August 11, 2023

RE Summary of repairs and recommendations obtained from the Milestone Phase 1 and 2 for
the building located at:

Las Vistas in Inverrary Condominium Association Inc.
3501 Inverrary Dr Bldg L, Lauderdale, FL 33319

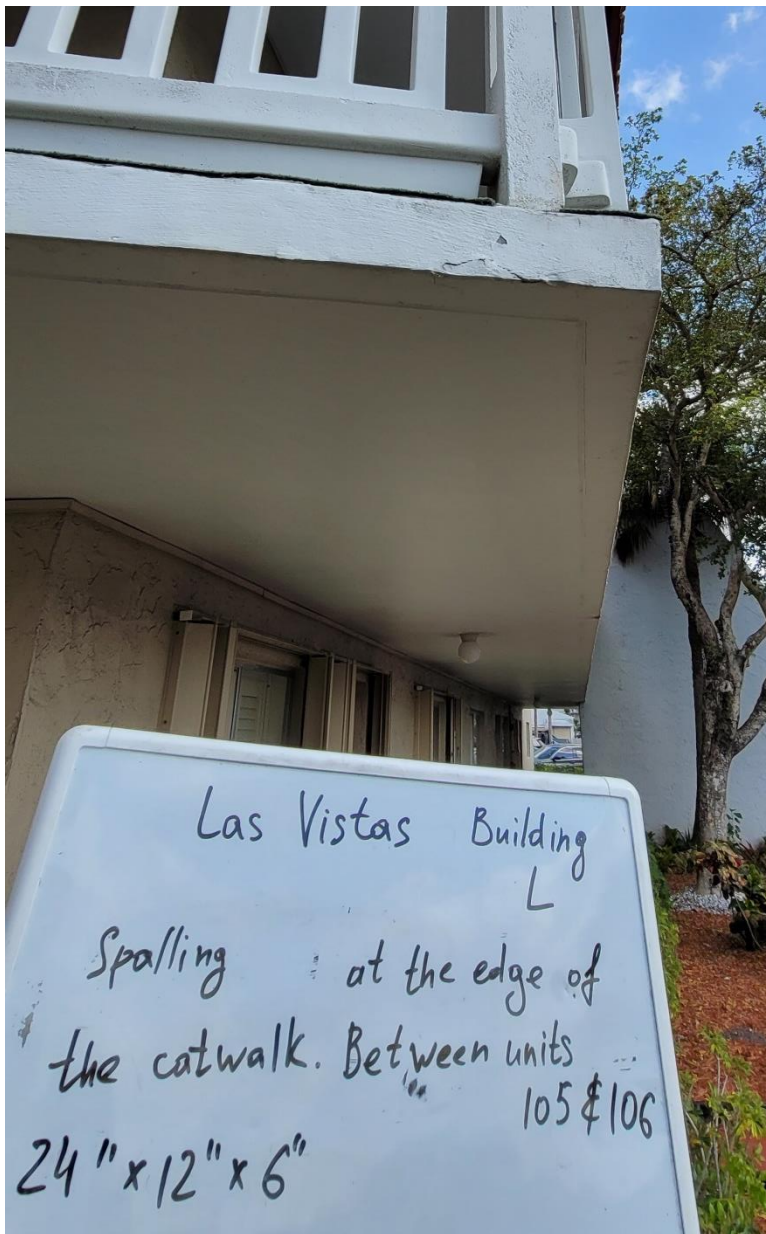
Spalling along the edge of the catwalk next to Unit 101

Spalling of the balustrade next to Unit 205

The listed deficiencies below must be corrected in accordance with a concrete restoration bid package prepared by a structural engineer and approved by the Local Building Department.

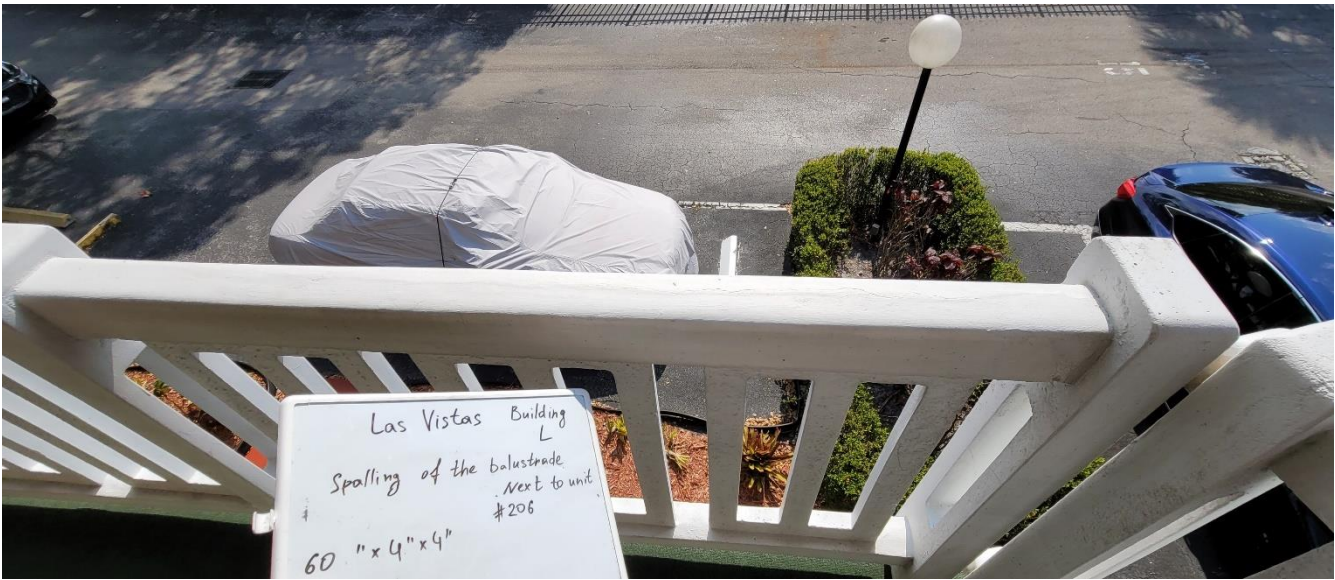
Spalling of the balustrade next to Unit 206

Stucco Unit 206

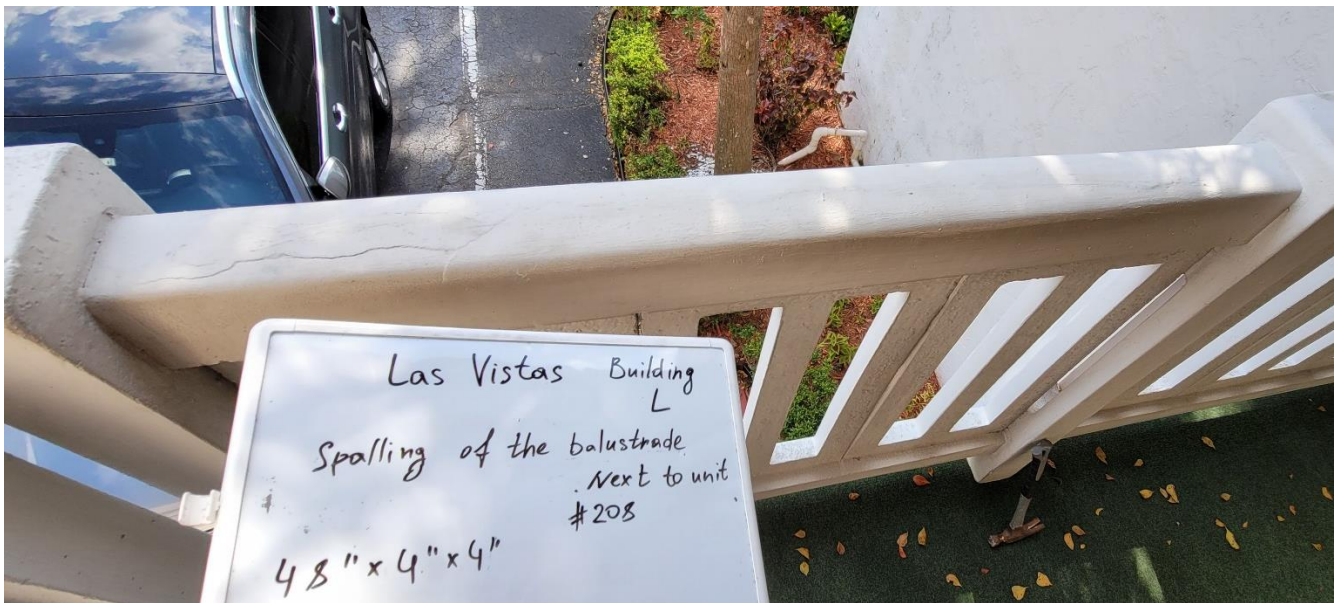
Spalling of the balustrade next to Unit 208

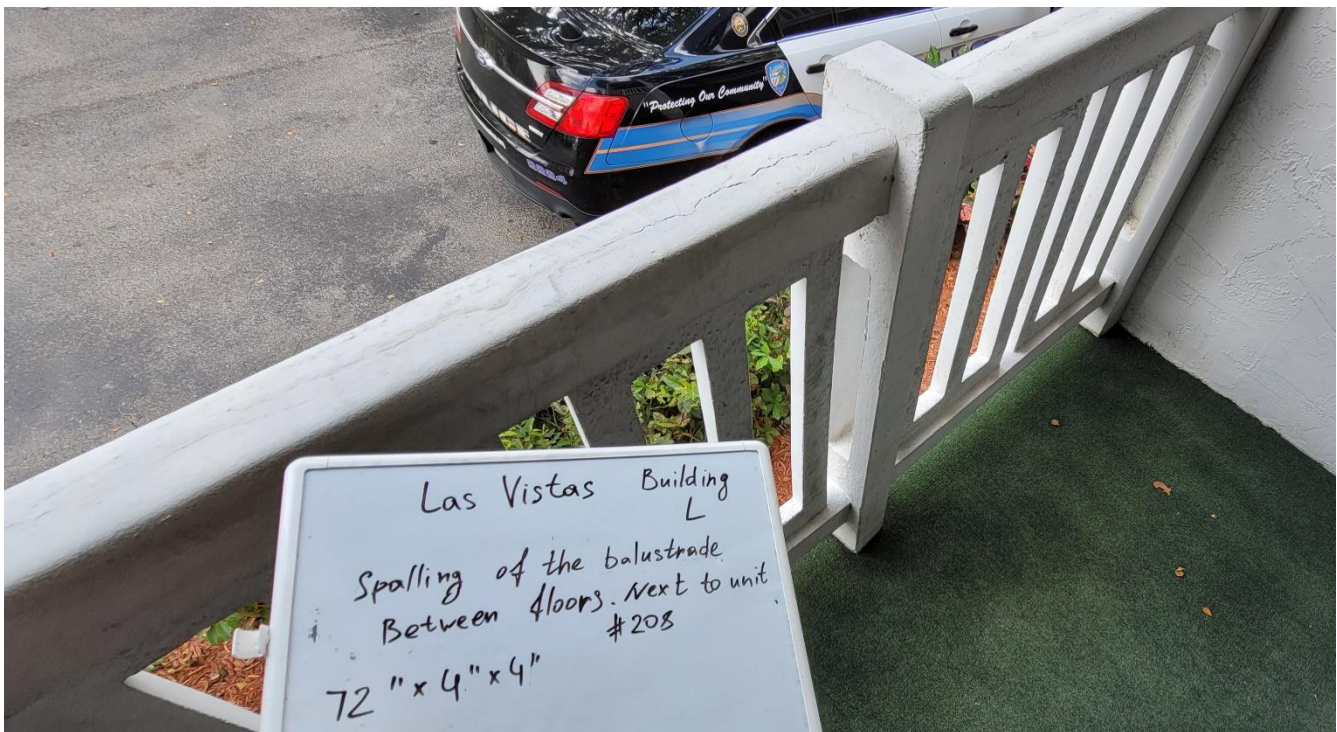
Spalling of the balustrade between floors next to Unit 208

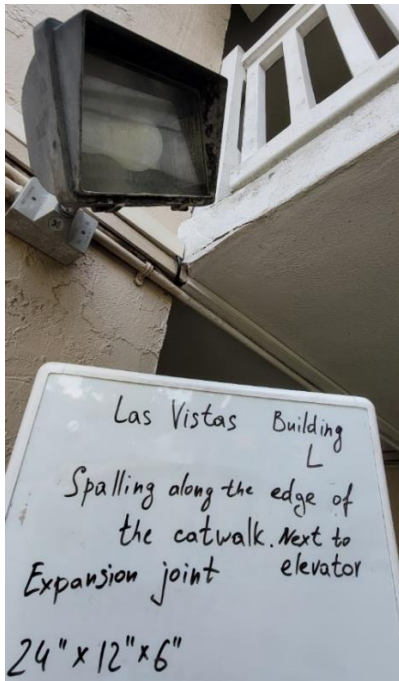
Spalling along the edge of the catwalk next to elevator

Roof (Single-ply roofing system with blisters)

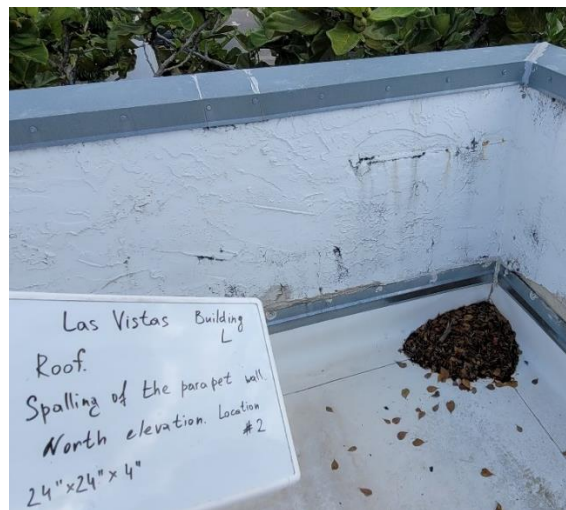
Spalling of the parapet North side

Spalling of the parapet East side

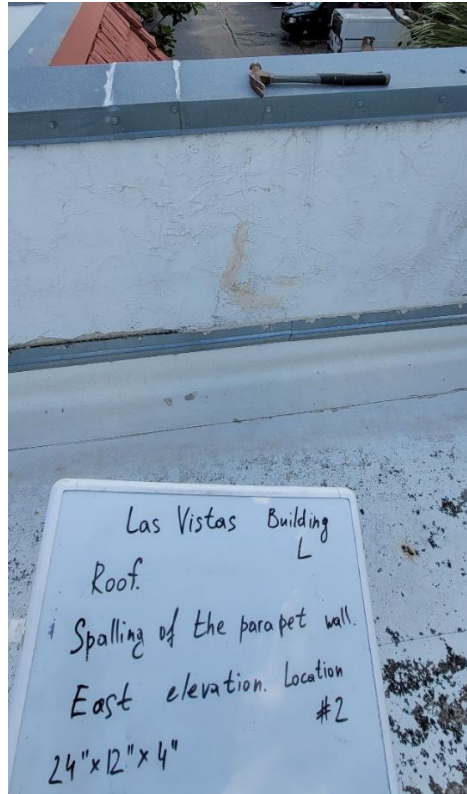
Roof (Roof system must be repaired)

Downspout next to elevator
